Project	IEEE 802.16 Broadband Wireless Access Working Group < http://ieee802.org/16 >	
Title	Proposal for Uplink Physical Structure Section (11.6.4) in the SDD document	
Date Submitted	2008-09-05	
Source(s)	Jeongho Park, Suryong Jeong, Taeyoung Kim, Hyunkyuu Yu, Jaeweon Cho, Heewon Kang, Hokyuu Choi, DS Park	Voice: +82-31-279-7528 E-mail: jeongho.jh.park@samsung.com
	Samsung Electronics	
	Sophie Vrzcic, Dongsheng Yu, Mo-Han Fong, Robert Novak, Hosein Nikopourdeilami, Jun Yuan, Kathiravetpillai Sivanesan	E-mail: svrzcic@nortel.com
	Nortel Networks	
	Xin Qi, Jianfeng Kang, Shaohua Li	
	Nokia Siemens Networks	
	Zexian Li	
	Nokia	
Re:	SDD Session 56 Cleanup; in response to the TGM Call for Contributions and Comments 802.16m-08/033 for Session 57	
Abstract	In order to provide FDM-based legacy PUSC support, a symbol structure is proposed.	
Purpose	Include the proposed text of section 11.6.4 in the SDD document

Proposal to Include Uplink Physical Structure Section (11.6.4) to the SDD document

[Figure X2 Subchannelization of 16m PUSC and DRU structure](#)

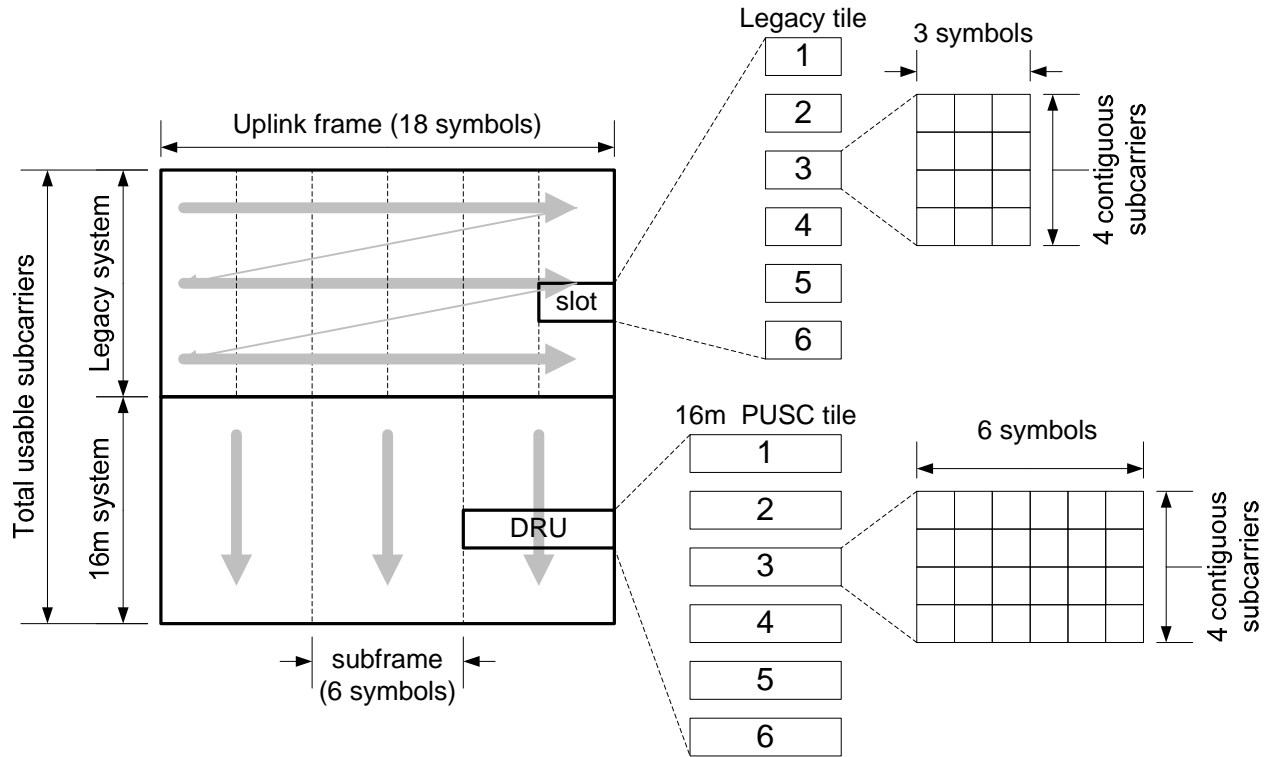
A subchannelization for 16m PUSC is identical to legacy uplink PUSC [2]. For a given system bandwidth, total usable subcarriers are allocated to form tiles (four contiguous subcarriers) and every tiles are permuted according to permutation defined in uplink PUSC [2]. Once subchannelization is done, every subchannel is assigned to either legacy system or 16m system. Figure X2 shows the uplink frame which is divided in frequency domain into two logical region – one is for legacy PUSC subchannels and the other is for 16m PUSC DRUs.
